Docket No. 50-0219-LR

**PRE-FILED DIRECT TESTIMONY OF DR. RUDOLF H. HAUSLER**

**INITIAL PREFILED WRITTEN TESTIMONY OF  
DR. RUDOLF H. HAUSLER  
REGARDING  
CITIZENS' DRYWELL CONTENTION**

Contour Plot for Bay 15 2006 External UT Measurements

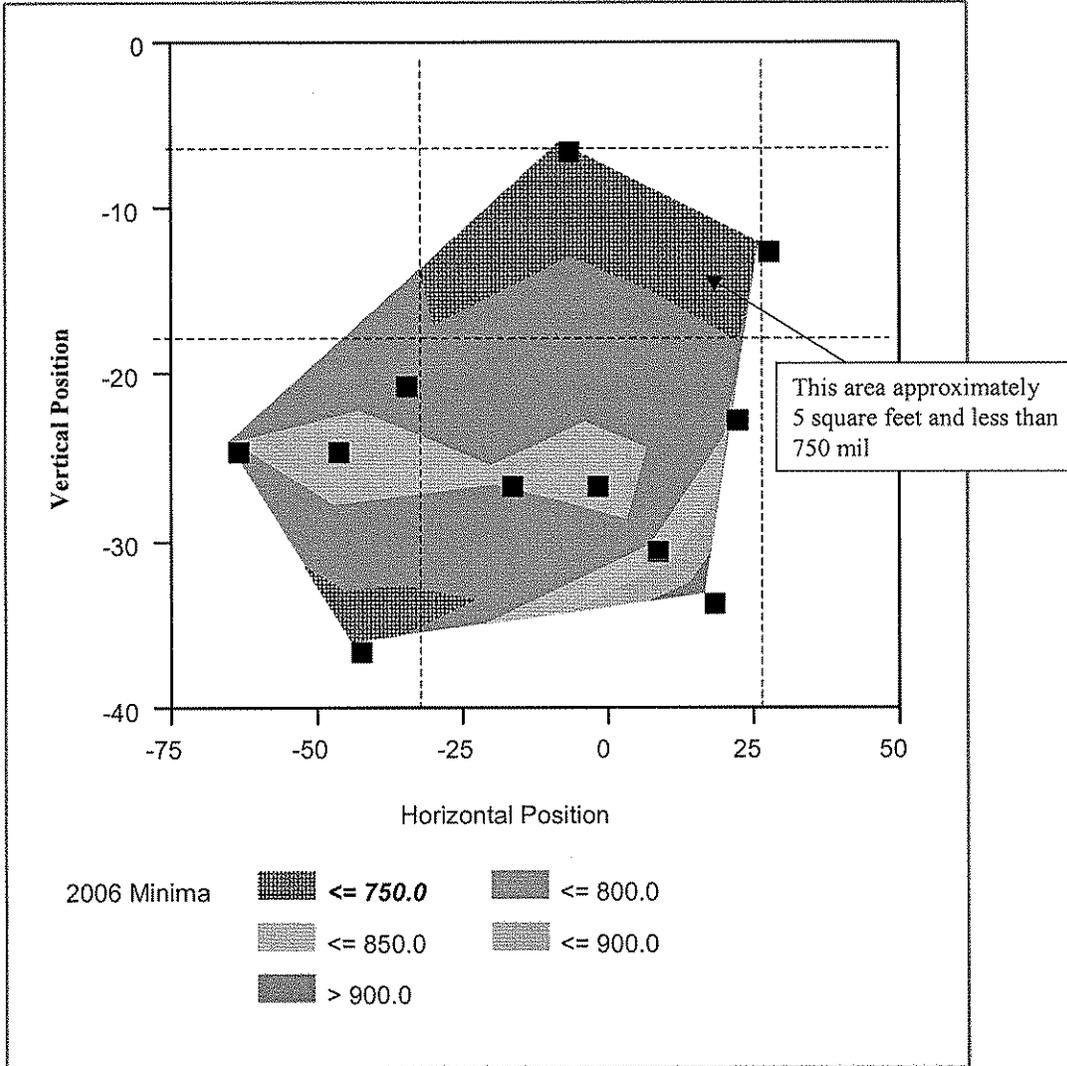
**Figure 6** shows the contours for Bay 15. There is a heavily corroded area at elevation -10 with an extension of 1 ft by about 4.5 feet. However, this area was explored only with 2 measurements and was not extended beyond about 2 feet either side of the centerline. It appears that the majority of the measurements occurred in the non-corroded zones. Interestingly there appears some serious corrosion near the sandbed bottom, but the occurrence was not further explored either.

Figure 7  
Contour Plot for External UT 1992 Data Bay 11

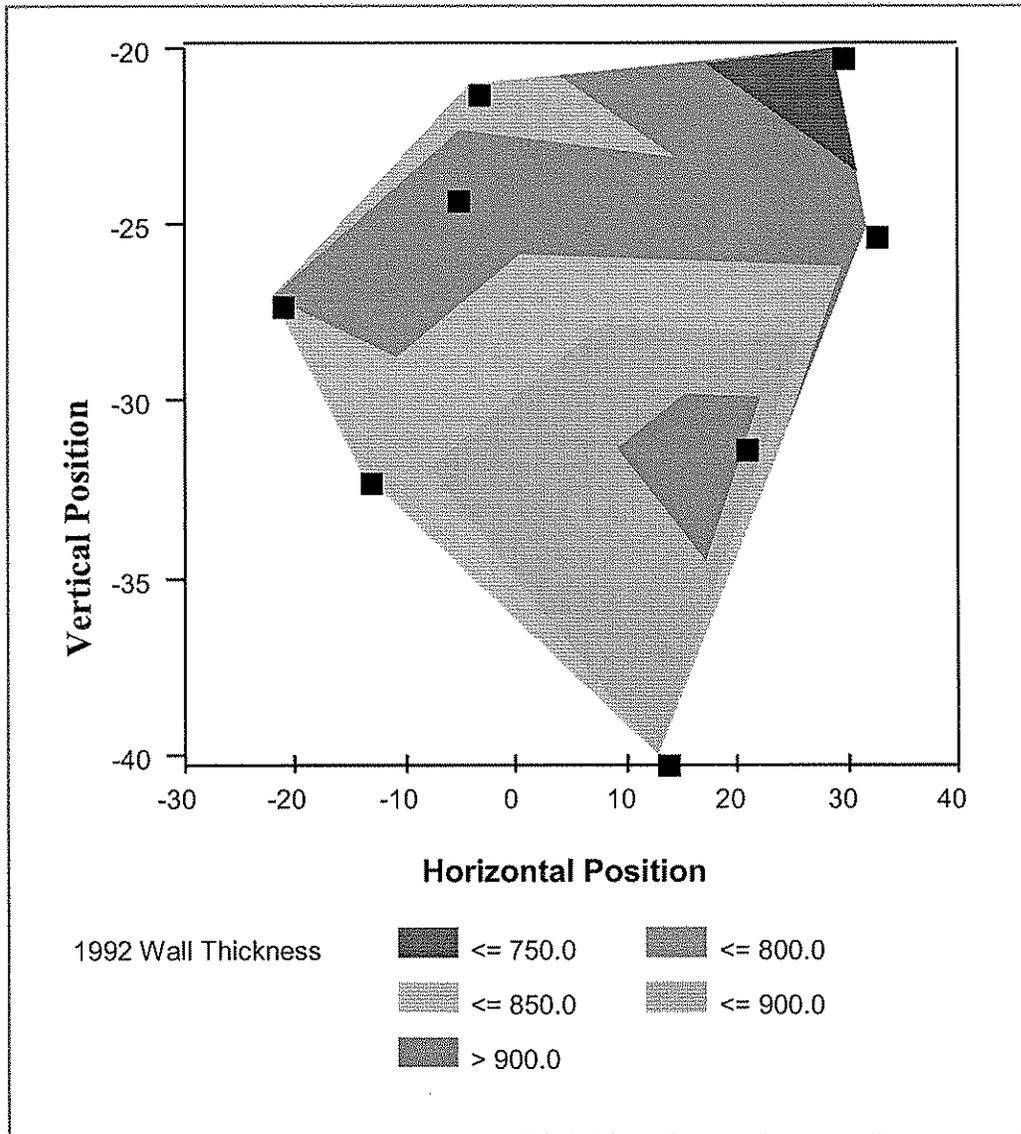
**Figure 7** shows the contours for Bay 11. Again there is a suggestion of severe corrosion at elevation -20 and no further exploration into the bathtub ring area. Once again, the extent of this area is highly uncertain because it was not further defined by additional UT measurements.
